Coe Pond Dam Inspection Findings

Kinneytown Hydroelectric Project (FERC No. 6985)

MARCH 2024

Figure 6.1-1. Proposed Breach of the Northern Weir

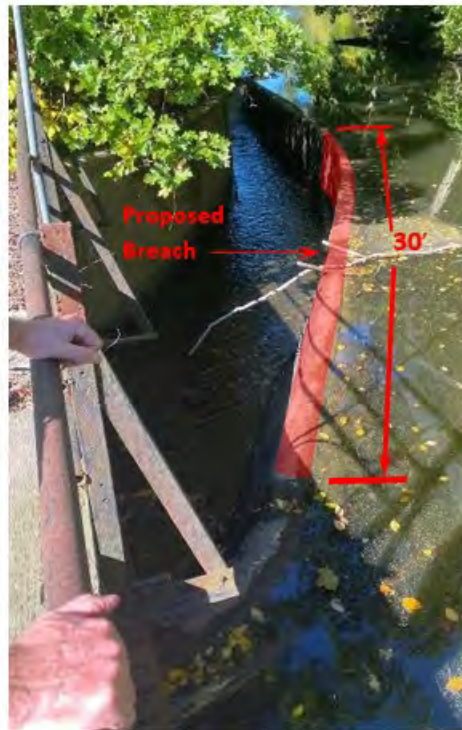
A photograph showing the approximate location to breach the northern weir is shown in [Figure 6.1-1](#). The removal will lower the weir crest to be within 6 inches of the concrete base slab (sizing of the weir breach is discussed below). This removal will result in lowering the normal water level in Coe Pond and Coe Pond by

approximately 3 feet, which will reduce the likelihood of future overtopping of the earthen dam. Not only will the normal pond level be reduced and provide more freeboard but it will also increase the discharge capacity at the northern weir during periods of increased inflow. It is also anticipated that by lowering the northern weir, the potential of developing an ice dam at south end of Coe Pond (which could result in overtopping) may be reduced. Other realized benefits from lowering the water level include reduced potential of seepage and reduced potential of a breach due to uprooting of trees.

The northern weir is approximately 65-feet-long and 3.83-feet-deep. If the entire weir were removed, it would provide a hydraulic capacity of approximately 1,624 cfs.
